**ADDENDUM NUMBER THREE  
TO THE REQUEST FOR PROPOSALS FOR OFFICE SYSTEMS FURNITURE DESIGN,  
PROCUREMENT, AND INSTALLATION  
LAKE COUNTY BOARD OF COMMISSIONERS AND LAKE COUNTY SHERIFF'S OFFICE  
ISSUED SEPTEMBER 13, 2024**

The County hereby amends the Request for Qualifications as follows:

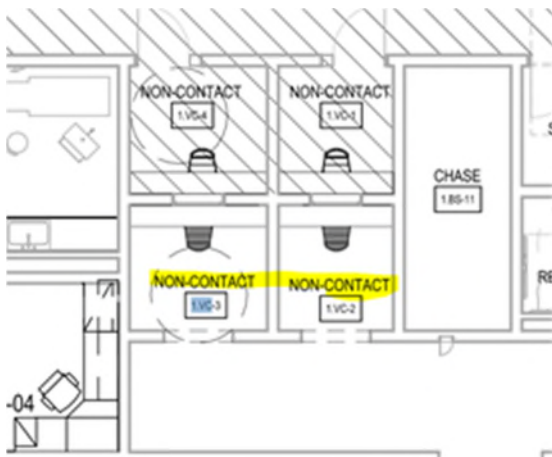
**RFI No. 33:** Workstations - throughout - On Page 6 of the Furniture Concepts they state that stacked transparent screens at 64" seated height preferred- Our question is do you want these stations to have panels at 42" high with a glass

stacker on top - which tallest stacker height is 15", that will bring it to 57" overall height- If you need it to get to 64" we can change the panel height to 50" with a 15" glass stacker to bring it to 65" high?

**Response: The client will need to review the proposed arrangement. Please propose what is most economical with the furniture you provide.**
